# HISTORIC AND DESIGN REVIEW COMMISSION

**HDRC CASE NO:** 2017-296  
**ADDRESS:** 115 S ZARZAMORA  
**LEGAL DESCRIPTION:** NCB 2322 BLK 1 LOT 7&8 AND 9  
**ZONING:** C-2,HL  
**CITY COUNCIL DIST.:** 5  
**LANDMARK:** Malt House Restaurant  
**APPLICANT:** Kaufman Killen  
**OWNER:** 7-Eleven Inc.  
**TYPE OF WORK:** Construction of a new convenience store and gas station

The applicant is requesting final approval of replacement plans on the property at 115 S Zarzamora. The applicant is proposing to construct a new commercial structure on the property including attached canopies and fuel pumps. The applicant will return at a later date for approval of a final new signage package to include freestanding, wall mounted, and window signage.

## Landscape Plan

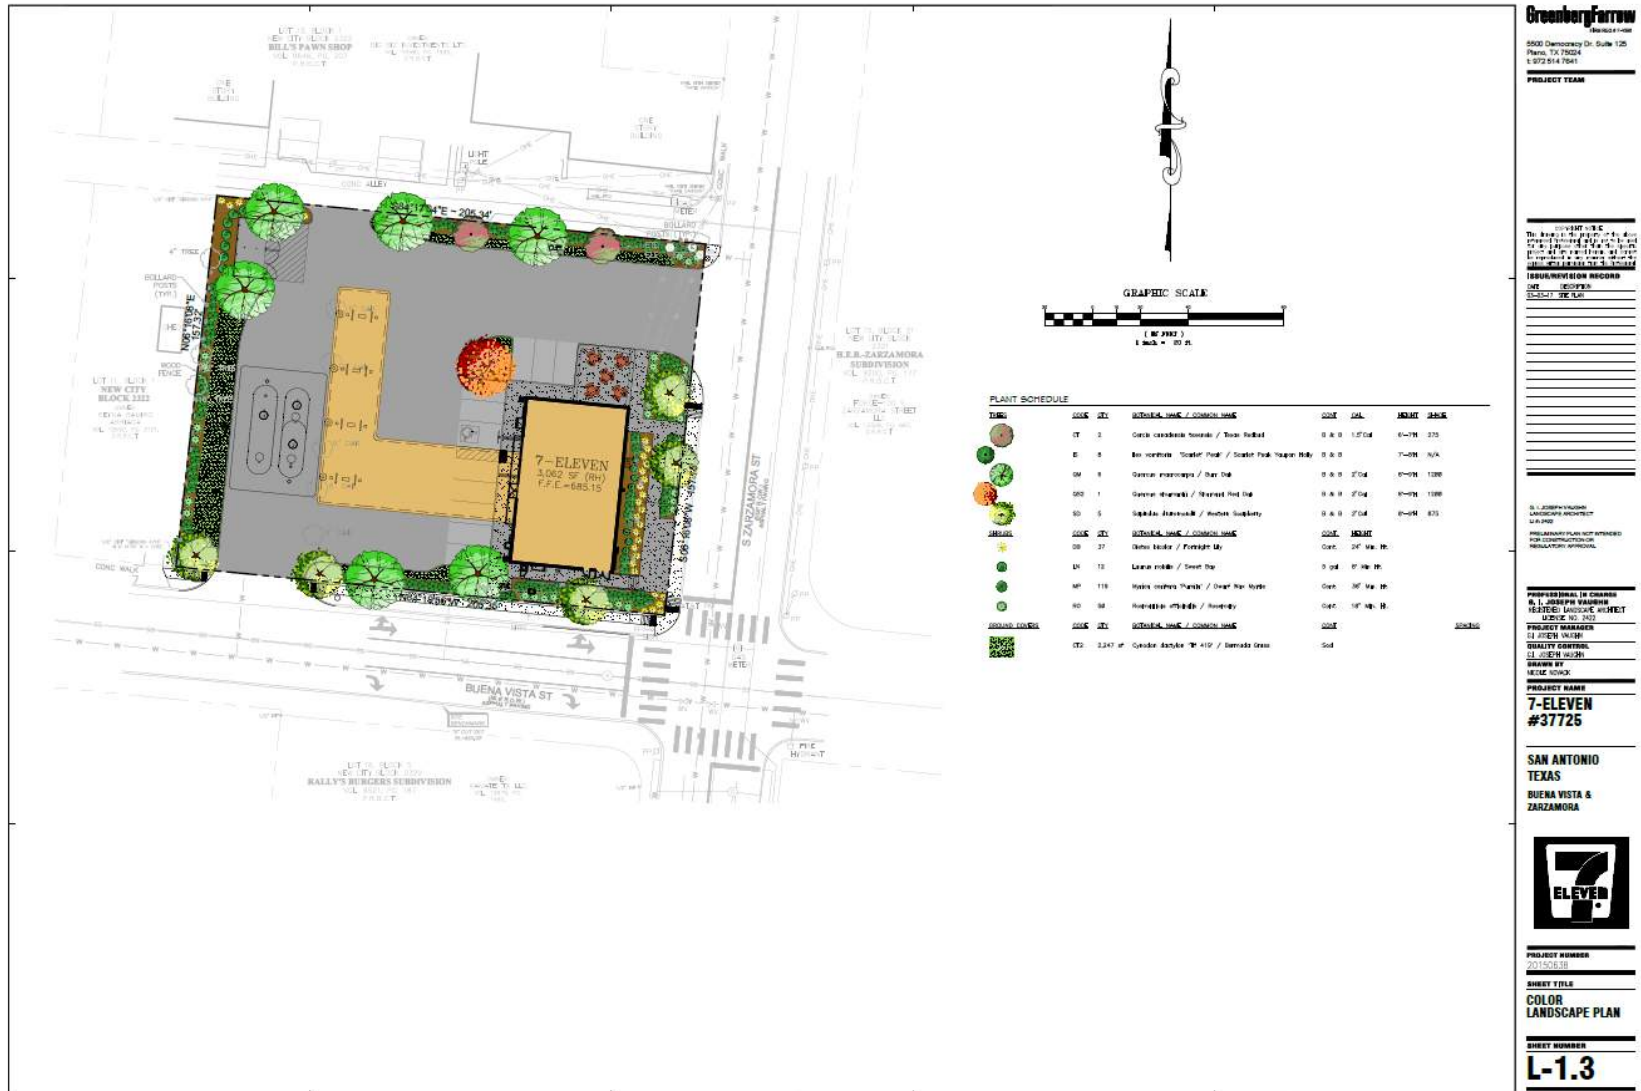
- r. **SITE ELEMENTS** – The existing site is paved with asphalt except for two planting strips with grass. The applicant is proposing a paved site with landscaping consisting of Bermuda grass, and various trees and shrubs along the west property line, north property line, and street frontages. According to the Guidelines for Site Elements 3, a varied plant palette with varied heights and native plant materials should be used; impervious surfaces should not be introduced where not historically located. Staff finds the proposed paving and landscaping consistent with the Guidelines.

Fuel Canopy Front Elevation  
1/8"=1'-0"

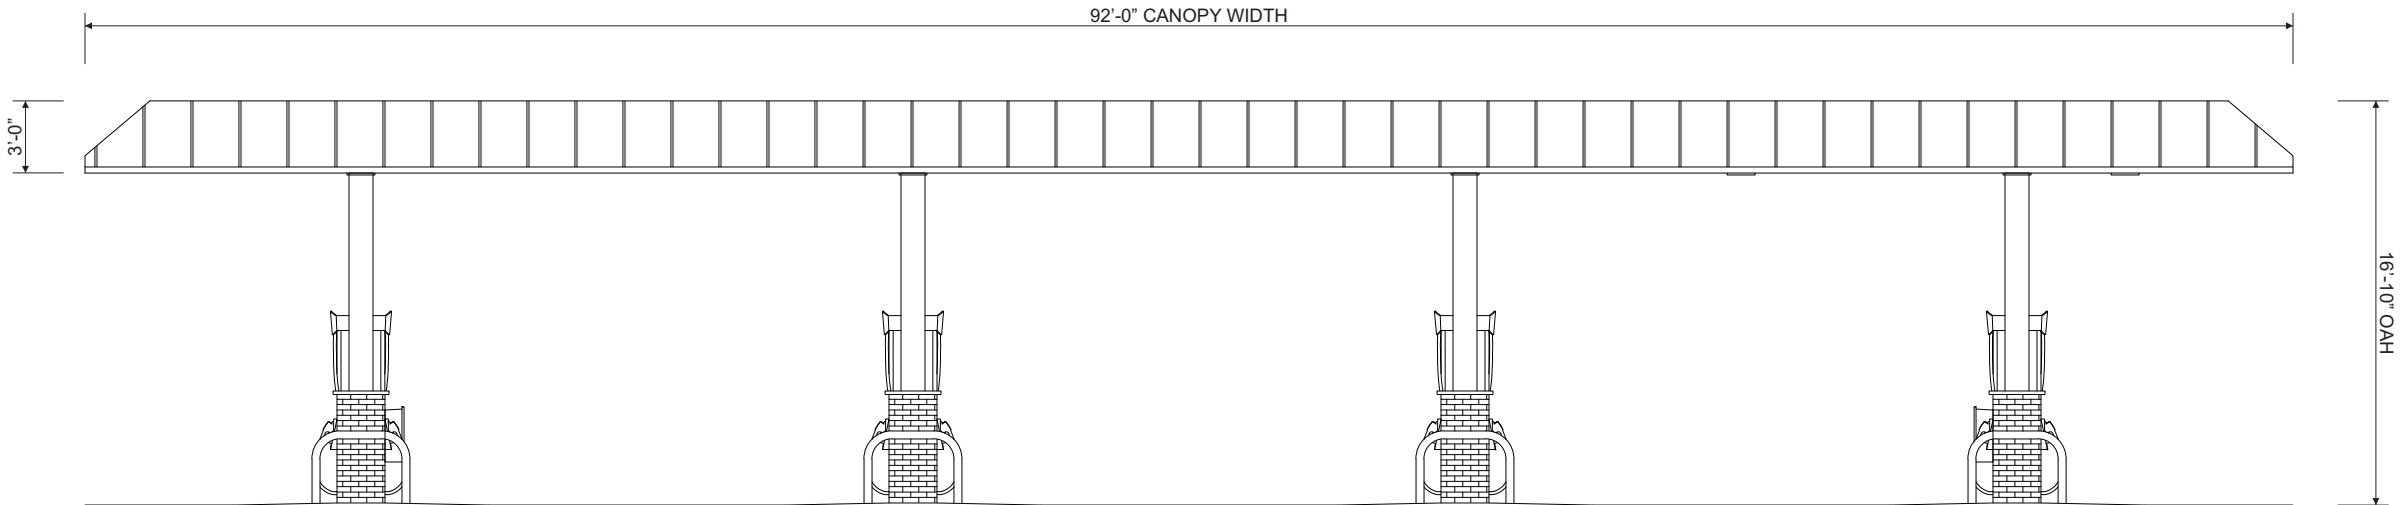
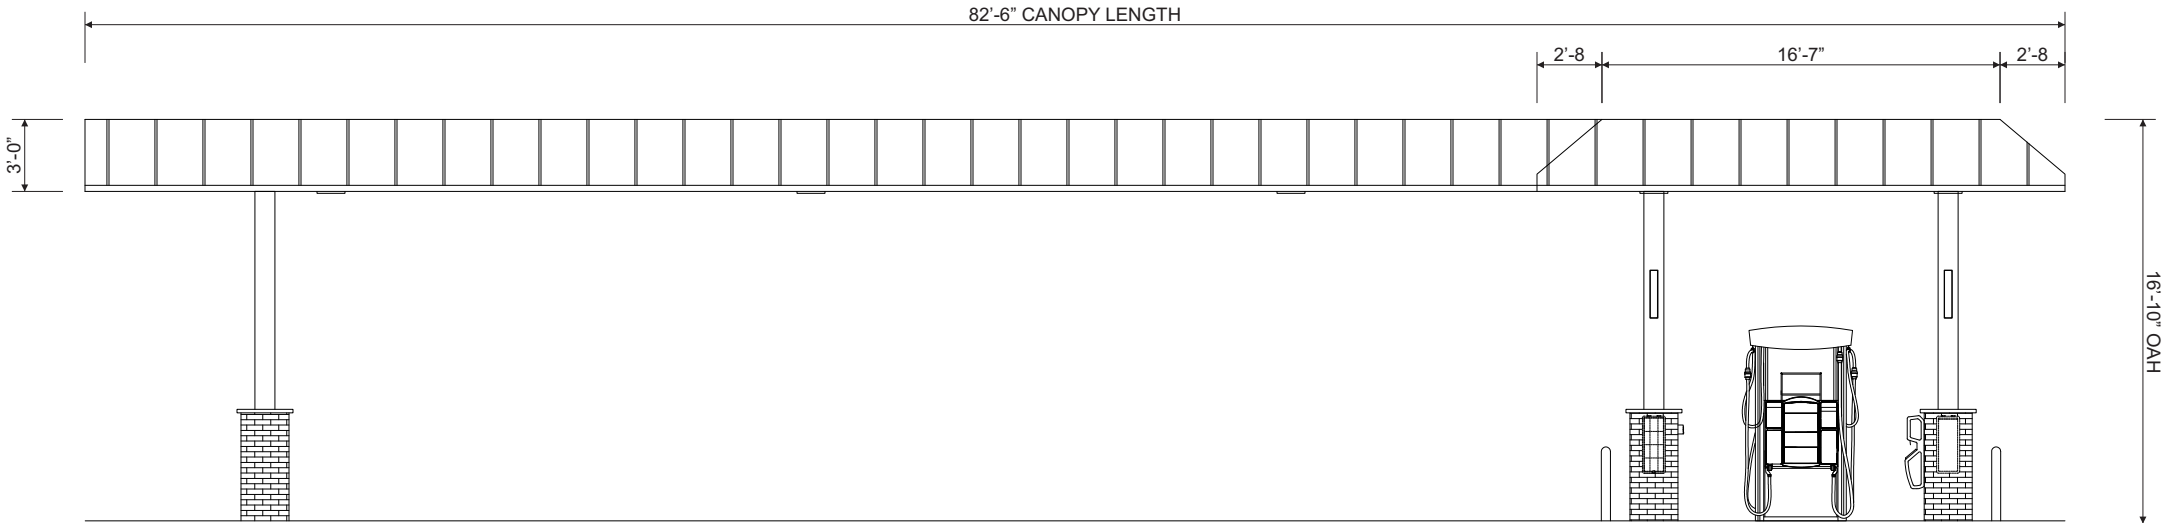
6. **That the canopy design be simplified and that the sloped roof edge be eliminated;** this stipulation has not been met in the current submittal.
  7. **That any window film used features interpretive elements such as historic photographs of the Malt House or Zarzamora corridor;** this stipulation has not formally been met, but the current submittal indicates that the plan is to include historic photographs or murals painted by local artists.

- p. **FUEL PUMP CANOPY DETAILS** – An existing attached canopy is situated to the south of the existing building which originally allowed for covered car-hop service. This is an important “Malt House” spatial characteristic that contributes to the sense of space. In the proposed replacement plans, a fuel canopy is located to the west of the proposed new commercial building. Staff finds that a fuel canopy can potentially provide an element that is similar to the original Malt House. However, the location, orientation, and design of the canopy should continue to reflect the existing spatial relationships on the property. In the submittal for final approval, the applicant has stated that the mansard look of the canopy has been maintained from conceptual approval based on the Commission. However, the final motion for conceptual approval included the staff stipulation that the canopy’s sloped roof detail be eliminated and a similar profile to the existing canopy of the Malt House be implemented. The canopy should be a simplified design that is more reflective of the existing Malt House design instead of the proposed sloped roof at its edges.
